## **Proposal for amendments to the proposal for Supplement 2 to the 01 series amendment text to UN Regulation No. 152 (Advanced Emergency Braking Systems for M<sub>1</sub> and N<sub>1</sub> vehicles)**

### **Submitted by the experts from the Informal Working Group on Advanced Emergency Braking Systems for vehicles of Categories M<sub>1</sub> and N<sub>1</sub>\*\***

The text reproduced below was prepared by the experts from the Informal Working Group on Advanced Emergency Braking Systems (AEBS) for vehicles of Categories M<sub>1</sub> and N<sub>1</sub> in order to supplement the proposals of document GRVA/2020/27 to improve the text on a number of issues. The modifications to the text of document GRVA/2020/27 are marked in bold for new and strikethrough for deleted characters

**Figure 1: LEFT TURN OR RIGHT TURN AT THE INTERSECTION**

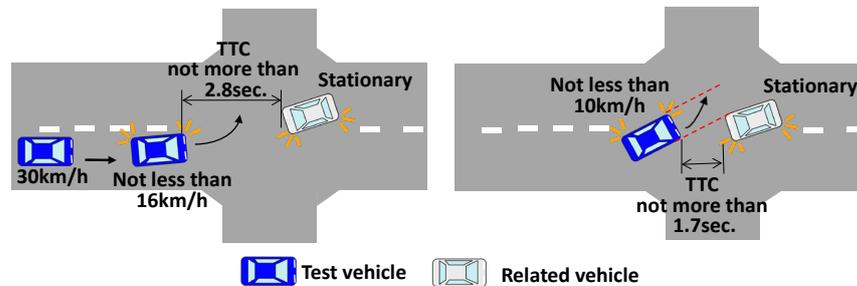
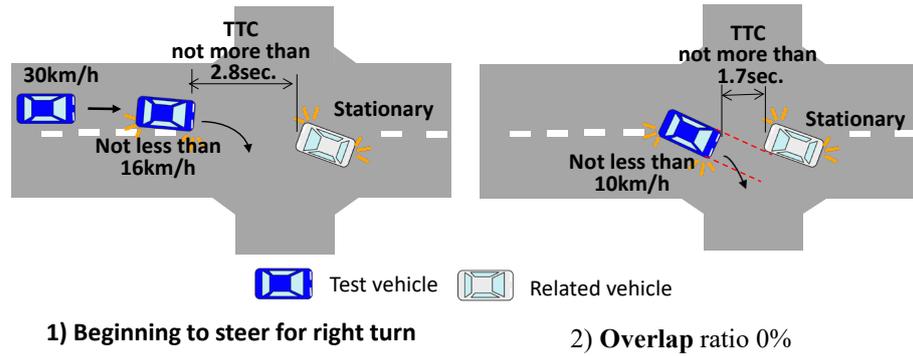
The TTC to the oncoming vehicle is not more than 1.7 seconds at when the ~~wrap~~ **overlap** ratio between the subject vehicle and the oncoming vehicle becomes 0%.

2) **Overlap** ratio 0%

Change of “wrap ratio” into “overlap ratio” and introduction of a definition of “overlap ratio”. The proposed drawings are improved accordingly.

Figure 2: right turn or left turn of a forward vehicle

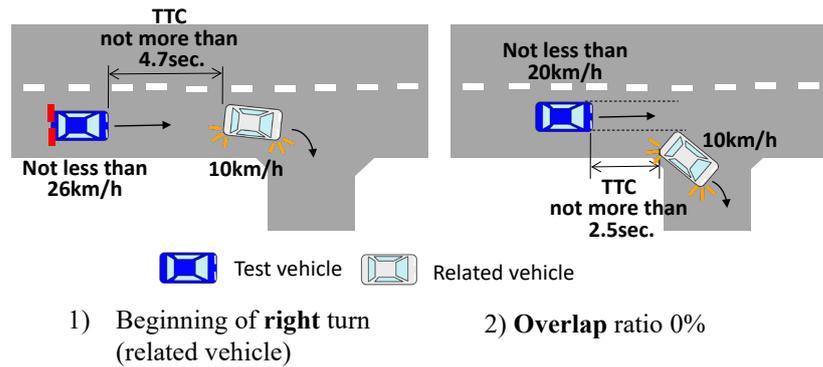
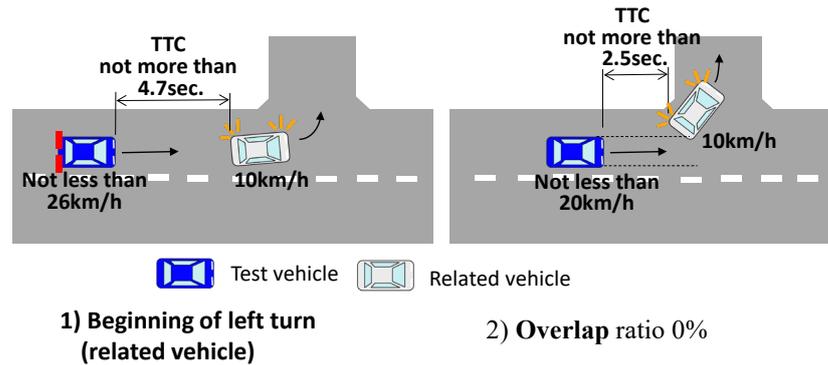
The TTC to the forward vehicle is not more than 2.5 seconds at when the ~~wrap~~ **overlap** ratio between the subject vehicle and the forward vehicle becomes 0%.”
